UNITED STATES  
NUCLEAR REGULATORY COMMISSION  
ADVISORY COMMITTEE ON REACTOR SAFEGUARDS  
WASHINGTON, DC 20555 - 0001

SUBJECT: TRANSMITTAL OF STATUS REPORT AND PROPOSED AGENDA FOR  
THE ACRS SUBCOMMITTEE MEETING ON JULY 10, 2012, RELATED  
TO THE LICENSE RENEWAL APPLICATION OF THE SEABROOK  
STATION

**NOTEBOOK MATERIAL  
PLANT LICENSE RENEWAL SUBCOMMITTEE MEETING  
SEABROOK STATION  
JULY 10, 2012  
ROCKVILLE, MARYLAND**

# Open Item – Bolting Integrity Program

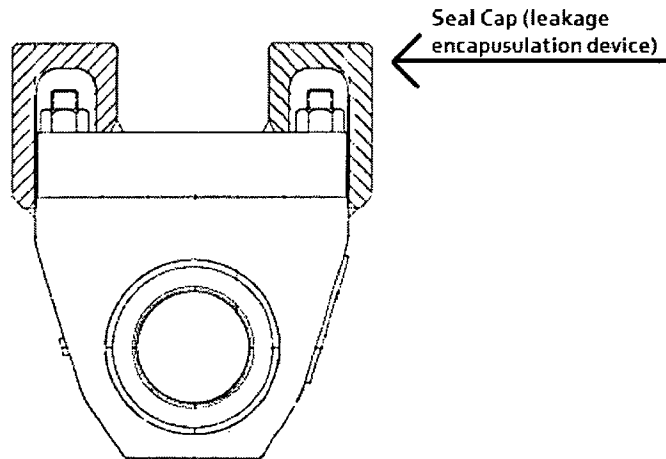
- LRA updated to add affected components to the One Time Inspection Program population.

# Open Item – Structures Monitoring Program

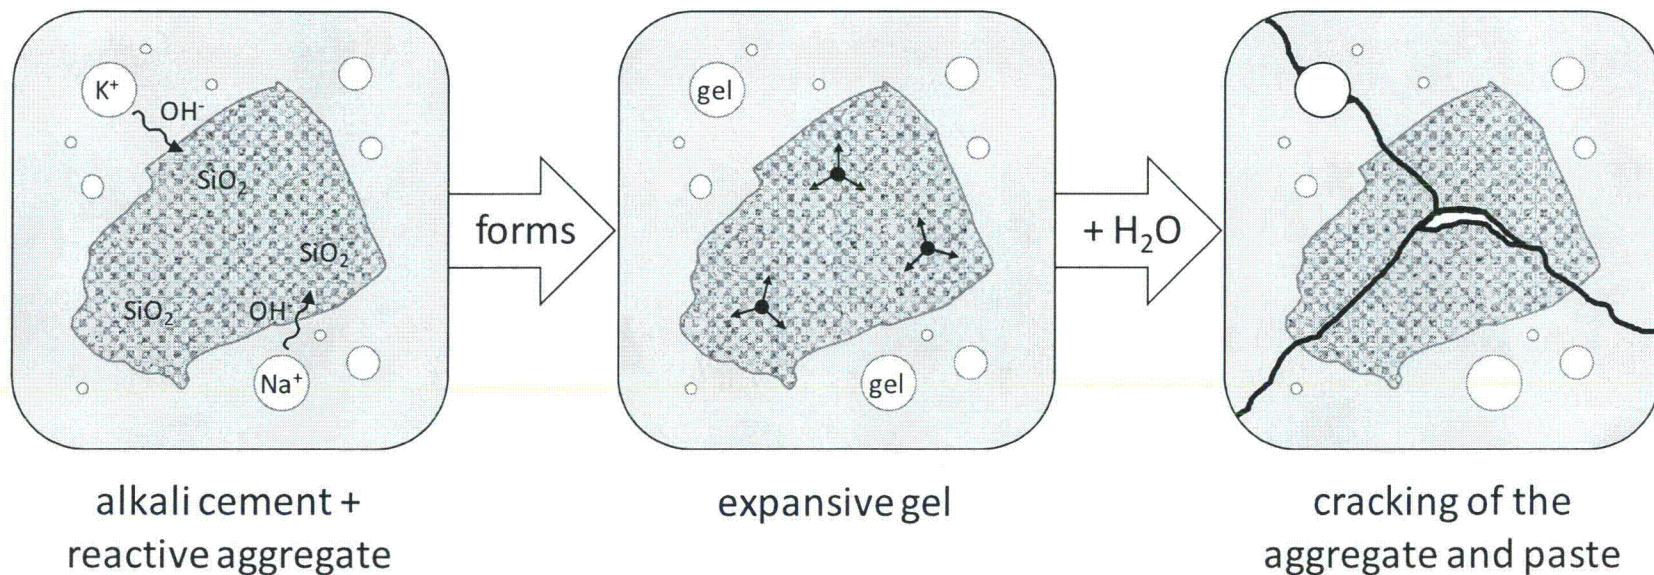
- LRA updated to:
  - Perform confirmatory UT testing of the containment liner plate in the vicinity of the moisture barrier
  - Implement measures to maintain the exterior surface of the Containment Structure, from elevation -30 feet to +20 feet, in a dewatered state.

### OI 4.2.4-1

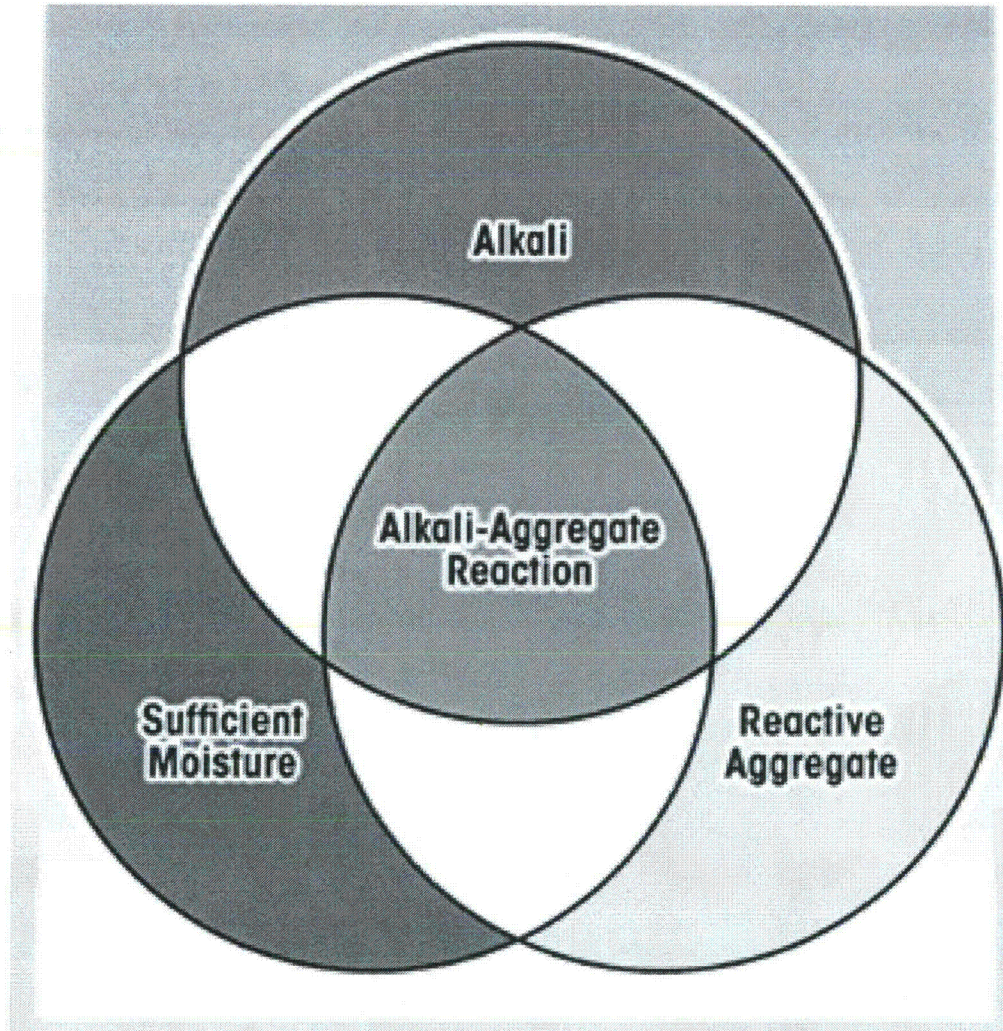
- Concerns that the methodology used to develop the P-T limits are not consistent with the requirements in 10 CFR 50, Appendix G.
